Talavera Floodplain Delineation Study Technical Review

Noah's Ark Group Study
Las Cruces, New Mexico
September 17, 2008

Hydraulics: Inflow Points

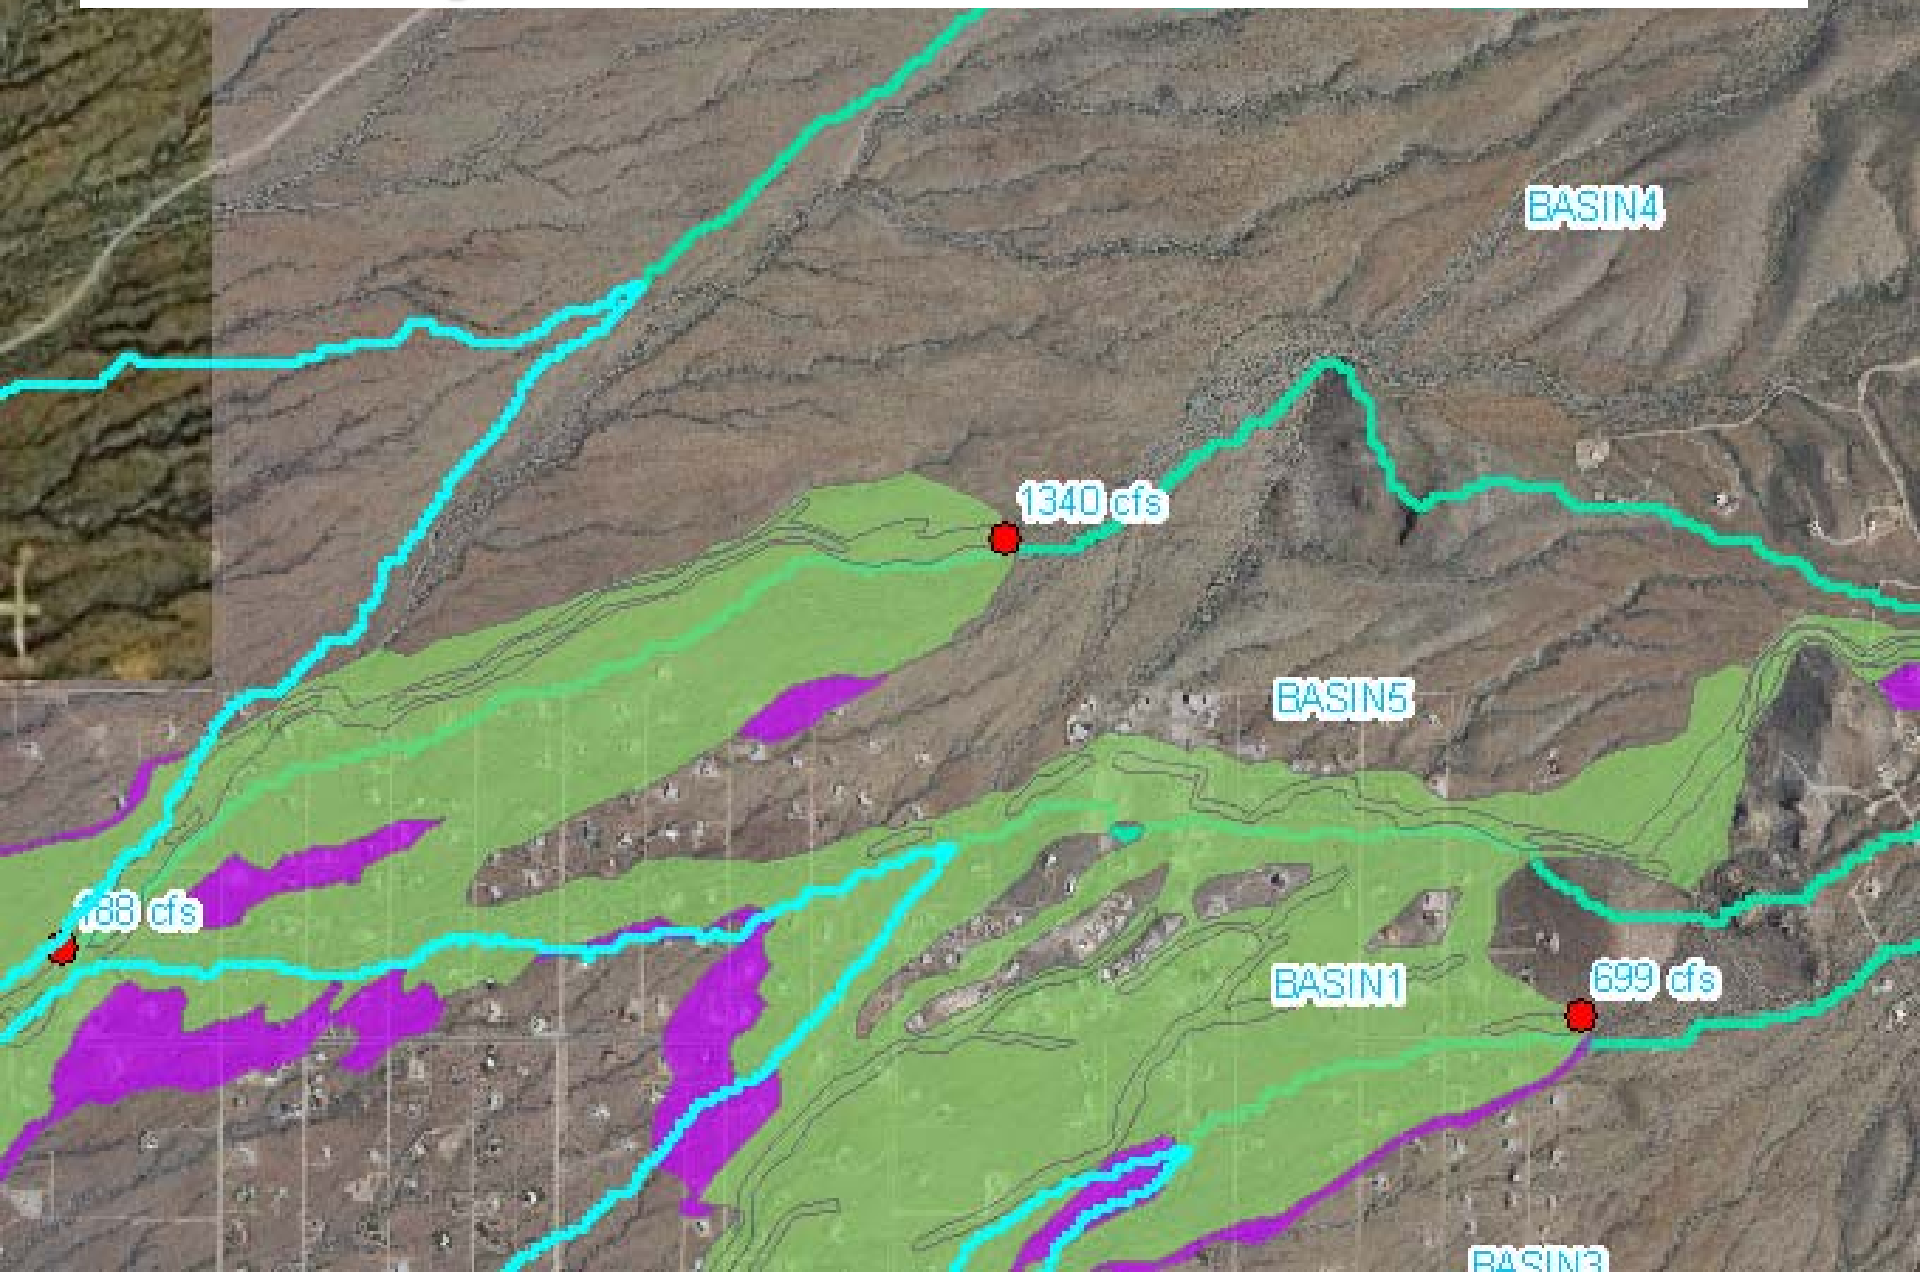
- FLO2D
 - Two-Dimensional Computer Model
 - Grid Based
 - State-of-the-Art
- Flaws in Application:
 - Hydrograph Shape
 - Discharge Inflow Points
 - Infiltration
 - Grid Size
 - Flow Channels Missed

Technical Flaws: Map Results

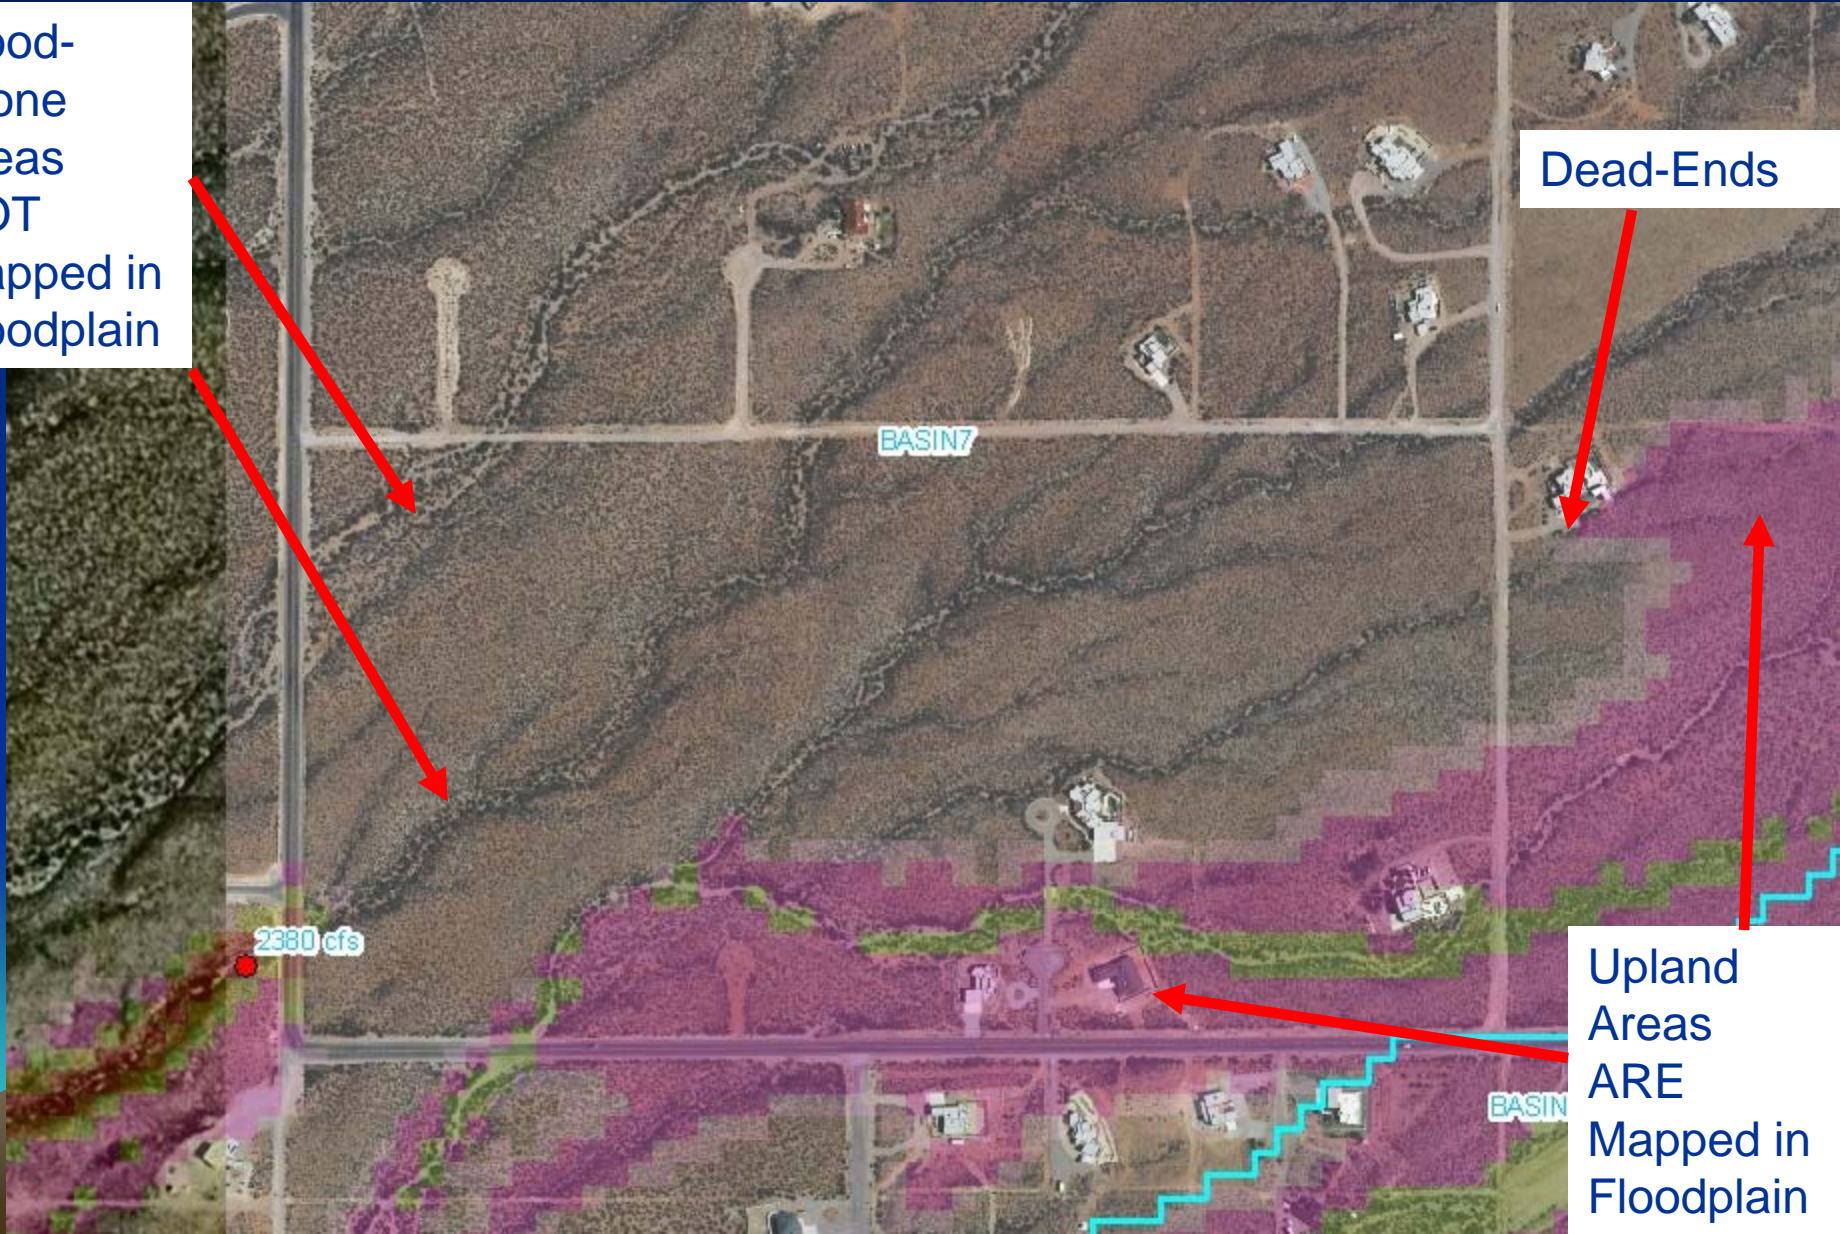
Flood-Prone Areas NOT Mapped in Floodplain

Dead-Ends

Upland Areas ARE Mapped in Floodplain

Technical Flaws: Map Results

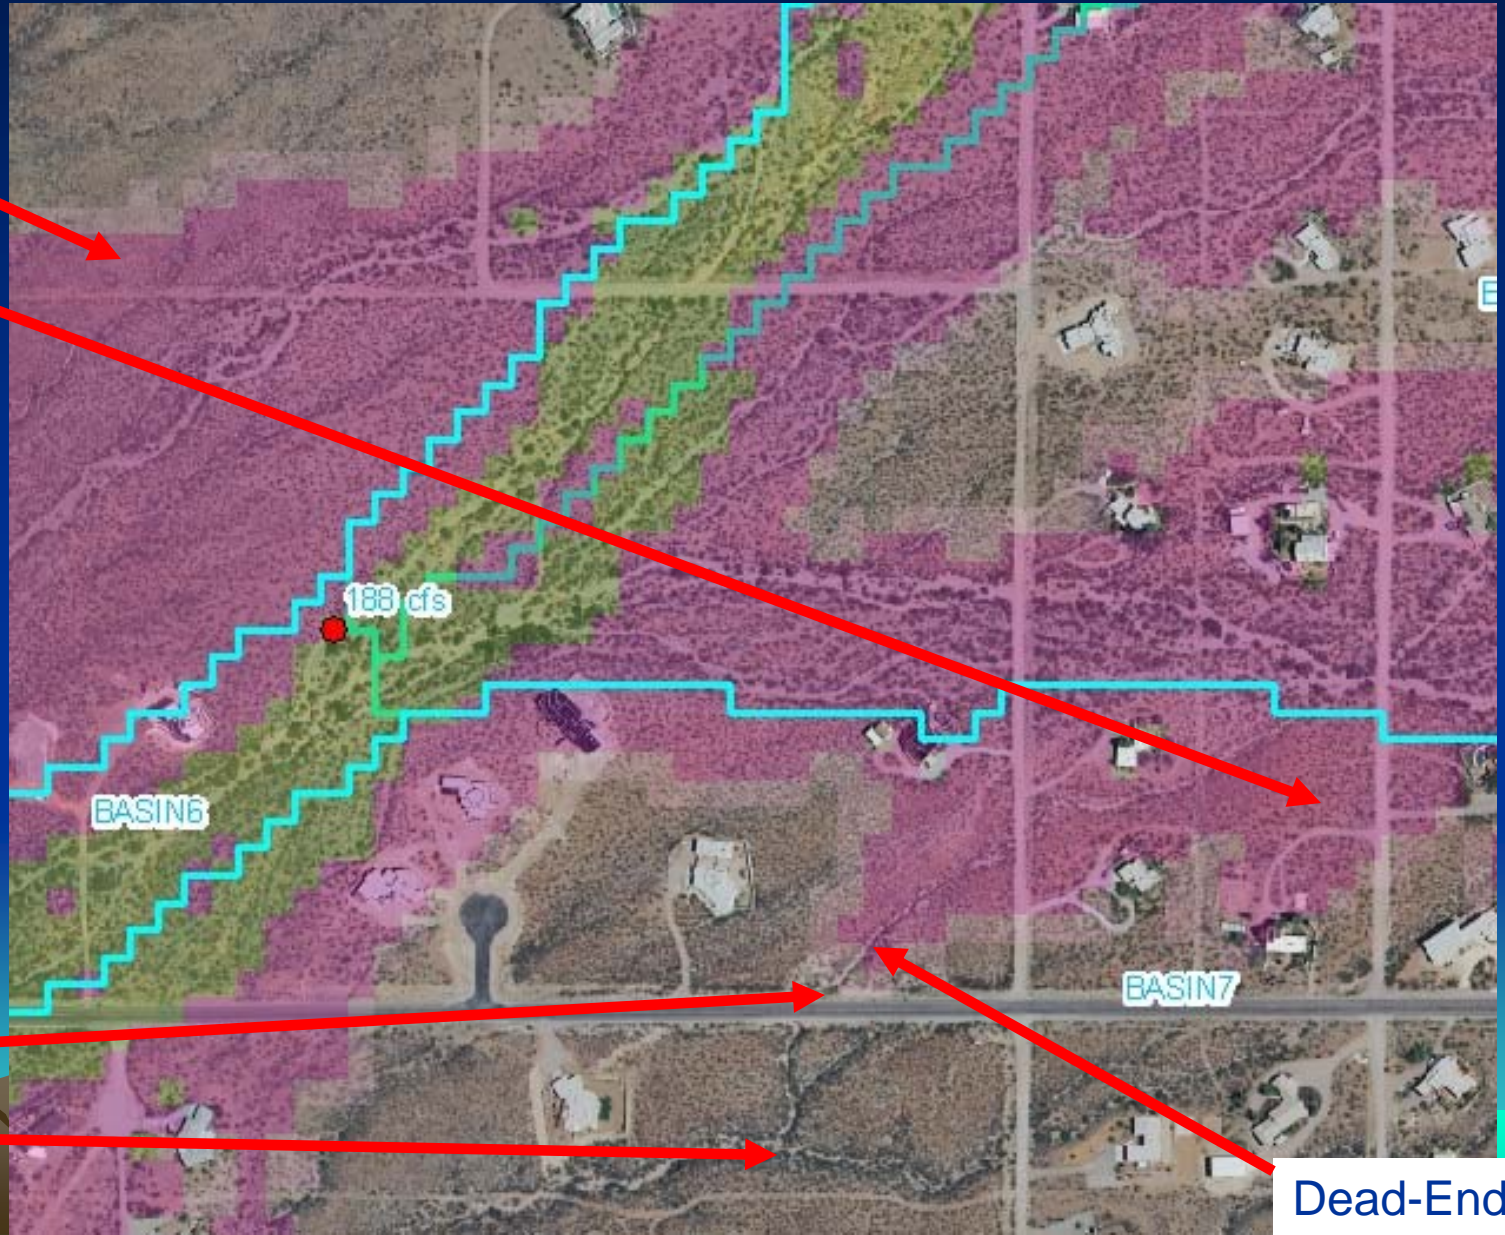
Upland
Areas
ARE
Mapped in
Floodplain

Flood-
Prone
Areas
NOT
Mapped in
Floodplain

Dead-Ends
